Product Bulletin

Tornado RC Control Box Support Bracket

*A Design Change Has Been Made To The Tornado Support Bracket to Improve Stability
Applicable for all Tornado RC monitors manufactured before April 2017.*

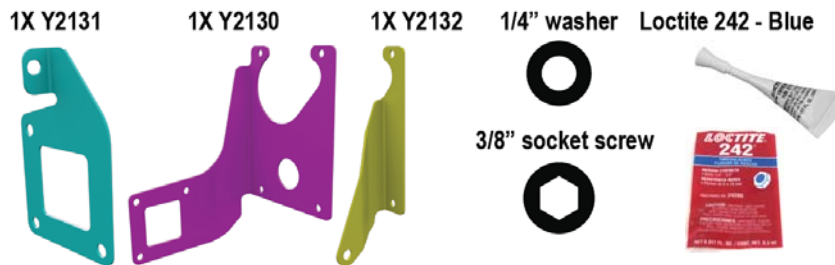
The Tornado RC Monitor was designed to use two control box support brackets to ensure stability in both horizontal and vertical directions. This continues to work for most applications. In an effort to improve performance in extreme conditions, an additional bracket has been added. An upgrade kit is available (Y2132-KIT). Future shipments of Tornado RC's will include this upgrade.

FEATURES	BENEFITS
Additional Bracket	Reduces the stress placed on the other brackets thus improving the durability of monitor controller components

The following Y2132-KIT is available and can be installed quickly using a 3/16" & 5/16" hex key.
